PLANNING COMMISSION STAFF REPORT

MEETING DATE: January 27, 2025

AGENDA ITEM TITLE: 223 W Third Street Minor Subdivision

The request is for a Minor subdivision replat for the property known as Lot 1, Welch Replat and Subdivision, City of Salida, Chaffee County, Colorado into two separate lots.

IMPROVEMENT SURVEY PLAT
LOT 1 WELCH REPLAT AND SUBDIVISION
CITY OF SALIDA,
COUNTY OF CHAFFEE,
STATE OF COLORADO
(223 W. 3RD STREET)

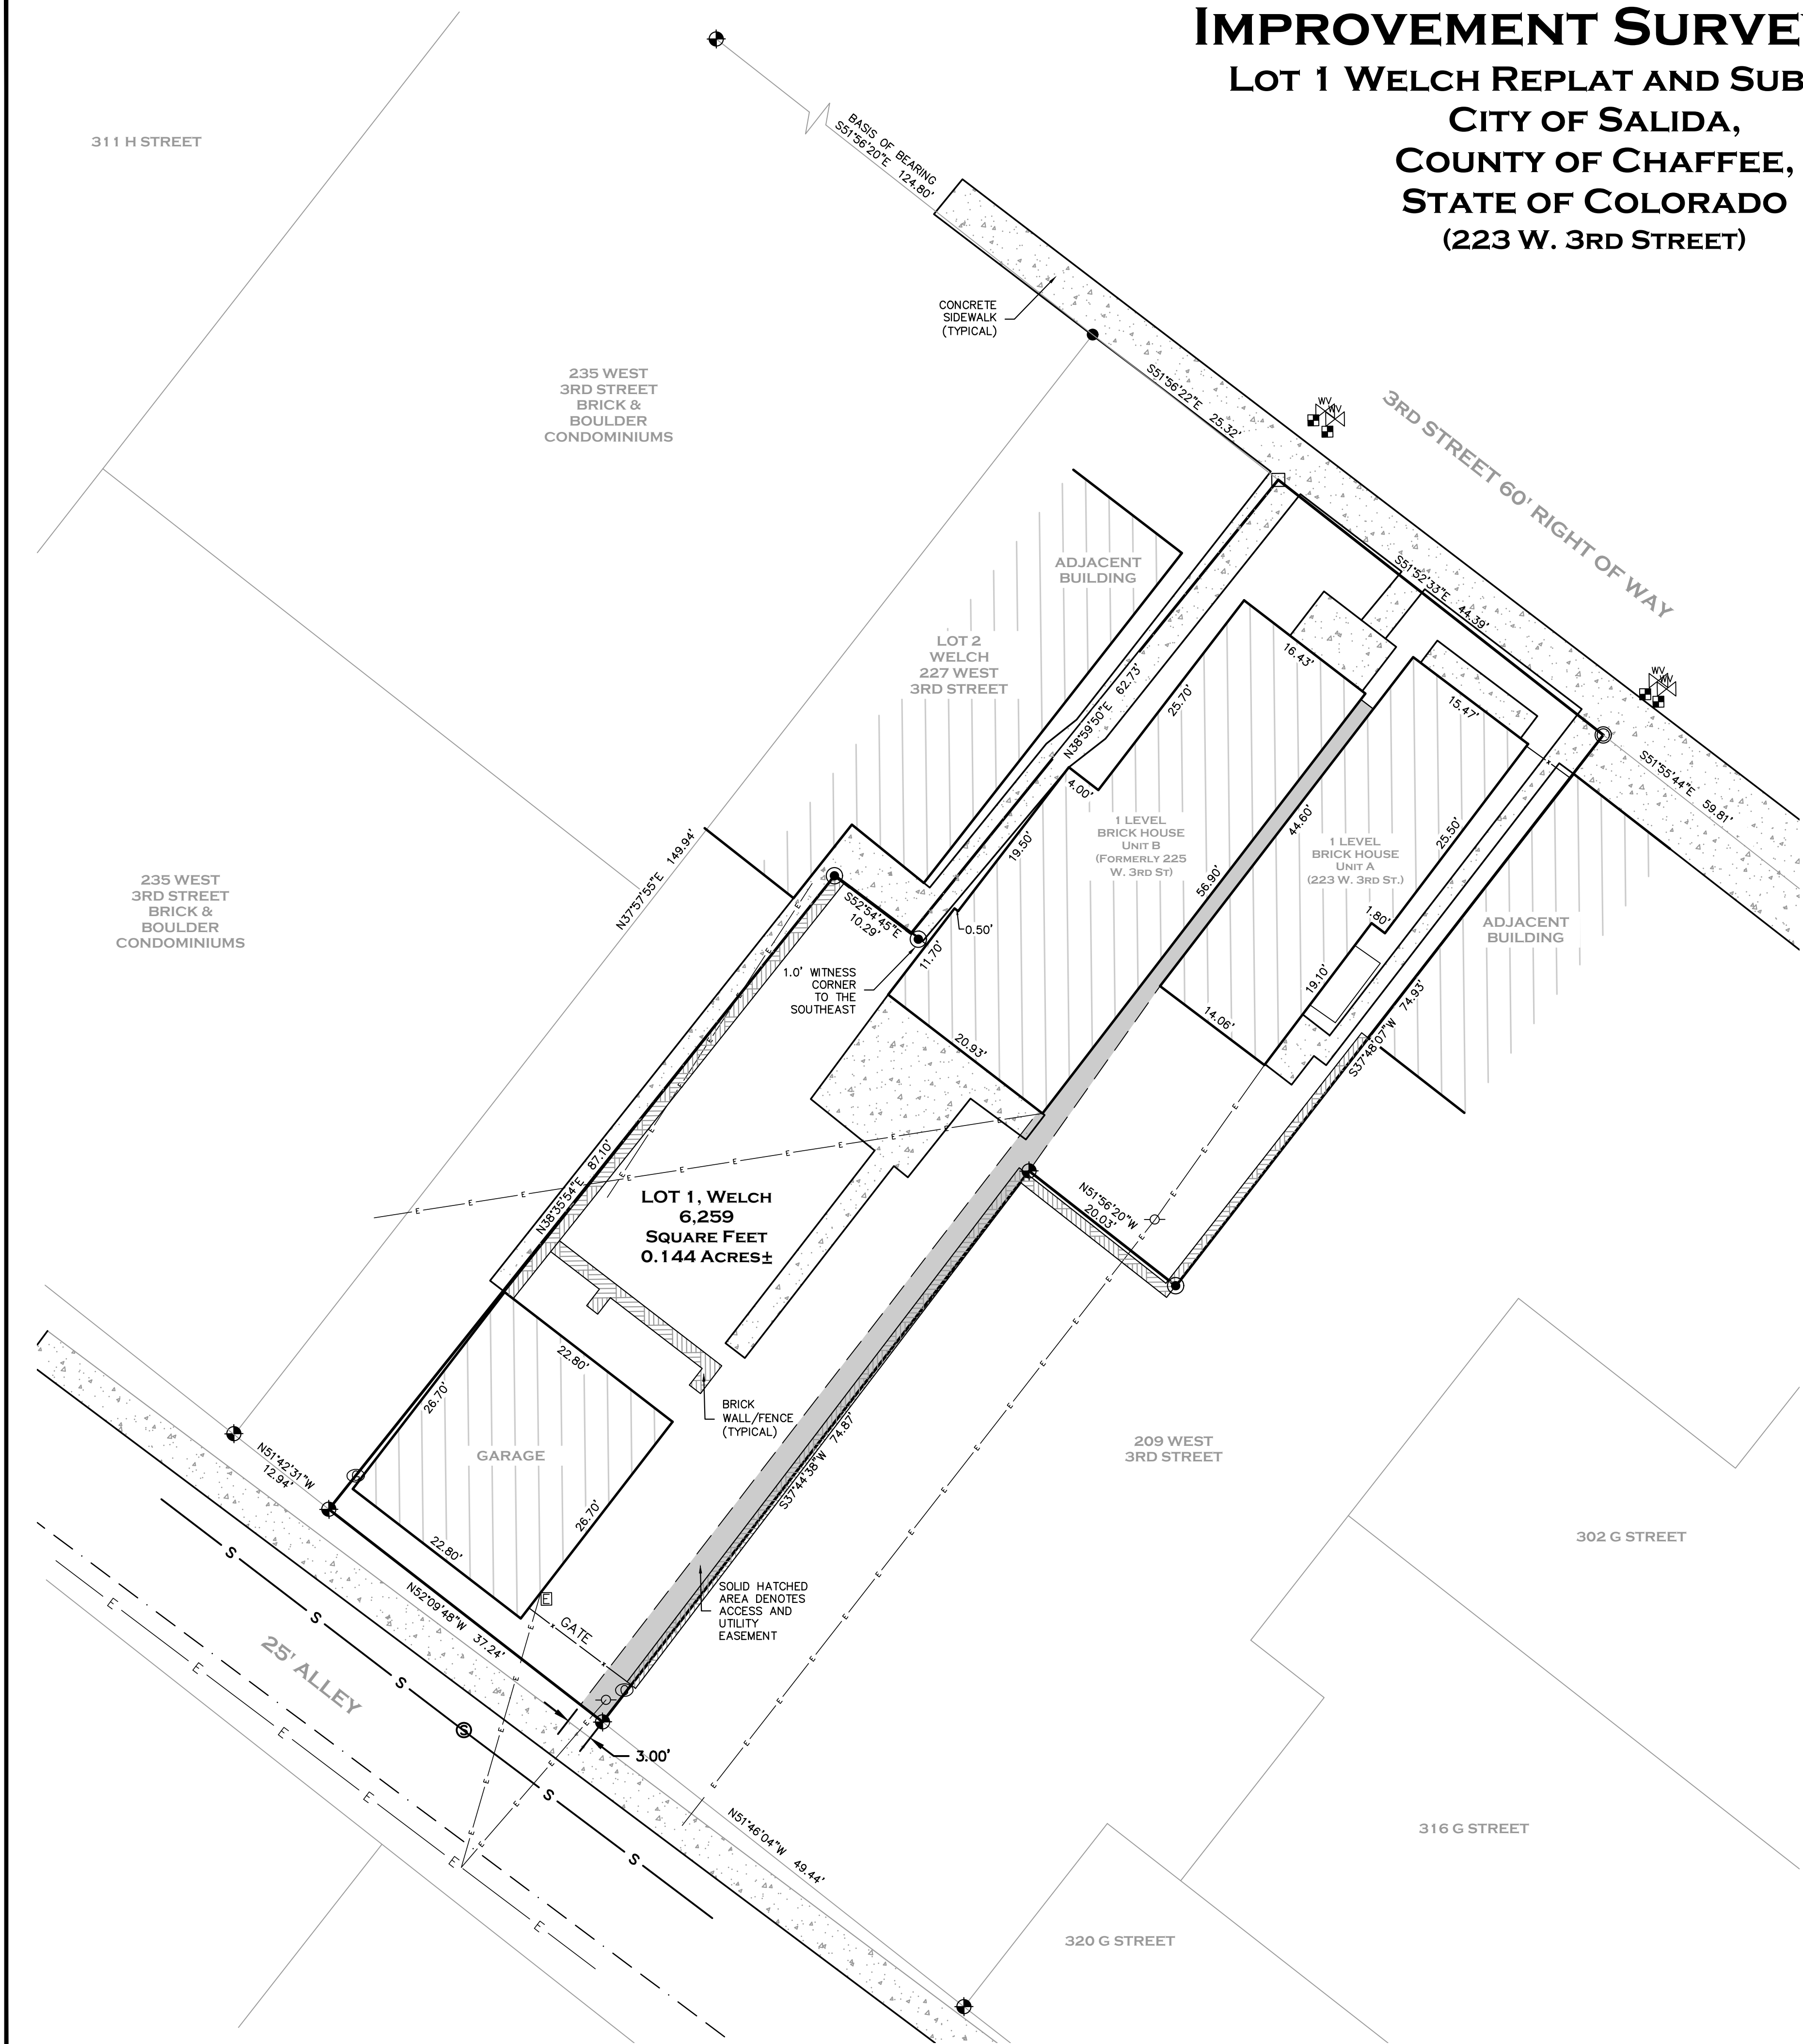
No subdivision plat meeting the requirements of Sec. 16-6-110 was included in the application, only an improvement survey plat which does not specify the exact dimensions of the newly proposed lots.
